**CITY OF ALBANY
PLANNING COMMISSION**
City Council Chambers, 333 Broadalbin Street SW
Monday, September 13, 2010
5:15 p.m.

SUBJECT: Public Hearing on Planning File CU-05-10; an application to add parking to Teloh Calapooia Park

STAFF REPORT Conditional Use

DATE OF REPORT: September 2, 2010
FILE: CU-05-10
TYPE OF APPLICATION: Conditional Use to add a three-space 2,081-square-foot parking area to an existing City park, Teloh Calapooia Park. There are no other parking areas on the site.
REVIEW BODY: Planning Staff, opportunity for a public hearing
STAFF REPORT PREPARED BY: Anne Catlin
PROPERTY OWNER: City of Albany
APPLICANT: City of Albany Parks and Recreation Department
APPLICANT REP: Craig Carnagey; Parks and Recreation; PO Box 490; Albany, OR 97321
ADDRESS/LOCATION: 5950 Looney Lane SW, Albany, OR 97321
MAP/TAX LOT: Linn County Assessor's Map No. 11S-04W-25; Tax Lot 708
ZONING: RS-6.5 (Residential Single Family)
TOTAL LAND AREA: 27.8-acre park
EXISTING LAND USE: Public Park
NEIGHBORHOOD: South Albany
SURROUNDING ZONING: North: RS-6.5, Residential Single Family
South: RS-6.5
East: RS-6.5
West: RS-6.5
SURROUNDING USES: North: Residential- single family
South: Residential- single

**Teloh Calapooia Park Improvements
Parking Lot Plan**

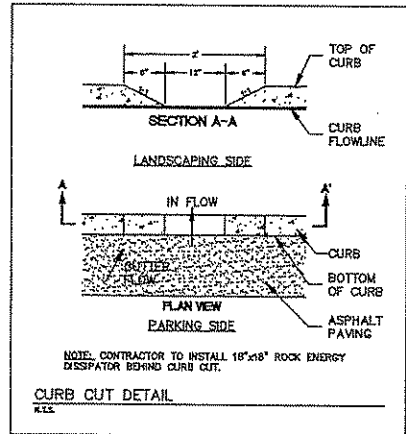
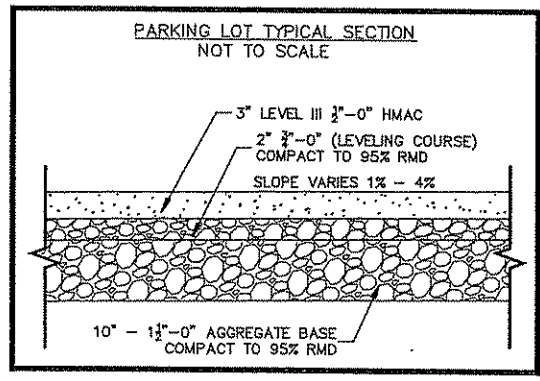
- 2.9 The 6-inch curb is proposed around the parking lot, the spaces are proposed to be striped, wheel stops are provided (although they are not needed because the spaces are not adjacent to a sidewalk), and one ADA parking space is provided.

- 2.10 Aisle Widths and Backup Areas. ADC 9.130 provides the minimum dimensions for parking stalls, travel aisles and back up areas. The proposed parking lot provides 90-degree stalls with a 26-foot-wide travel aisle. The ADA space is located on the north side of the parking lot and the 8-foot striped area adjacent to the parking stall allows for a larger back up space for vehicles than required.

- 2.11 Pedestrian Access. An existing walkway connects the sidewalk on the east side of Looney Lane with the park path system. A walkway is also provided from the parking lot to the park path system. The construction details show various ramps within the park. All new public walkways and handicapped accessible parking spaces must meet the minimum requirements of the Oregon Structural Specialty Code and the Oregon Transportation Commission Standards for Accessible Parking Places (April, 2008). The maximum vertical slope of the handicap ramp to the sidewalk is 8.33% over 3 feet, and horizontal slope is 2%.

- 2.15 Parking Area Landscaping Needed. The site plan was revised to meet backing up requirements, so the landscape plan needs to be modified to reflect the new orientation and to provide the parking lot "planter bay" landscaping at the south and north ends of the parking stalls according to ADC 9.150.

- 2.19 In order to minimize any impacts from head lights, evergreen shrubs or something similar should be planted in front of the forest canopy edge on the west side.

- 4.4 The applicant's preliminary plan shows breaks in the perimeter curbing for the parking lot that will allow runoff from the parking surface to flow to the existing drainage swale adjacent to the site. Because of the proximity of the parking lot to the drainage swale the City's Engineering Division approves of the applicant's proposal to discharge runoff through the curbing.

- 2.1 Except as modified by any conditions of approval, the new 3-space parking area shall be constructed as shown on the revised site plan received July 29, 2010.

- 2.2 The ramp from the parking lot to sidewalk and ramps to the play areas off the internal path shall be constructed per the 2010 Oregon Structural Specialty Code and the Oregon Transportation Commission Standards for Accessible Parking Places, April 2008.

- 2.3 Minimum Required Landscaping of Parking Area.
 - (1) Planter Bays. The planting area at each end of the parking bay (north and south) shall contain:

- 5.1 The parking lot shall be lit with motion-sensor lighting and/or other types of security lighting. Lighting shall be directed away from residential properties and shall not cast glare on abutting residential properties.
- (6) *Any special features of the site (such as topography, floodplain, wetlands, vegetation, historic sites, etc.) have been adequately considered and utilized.*
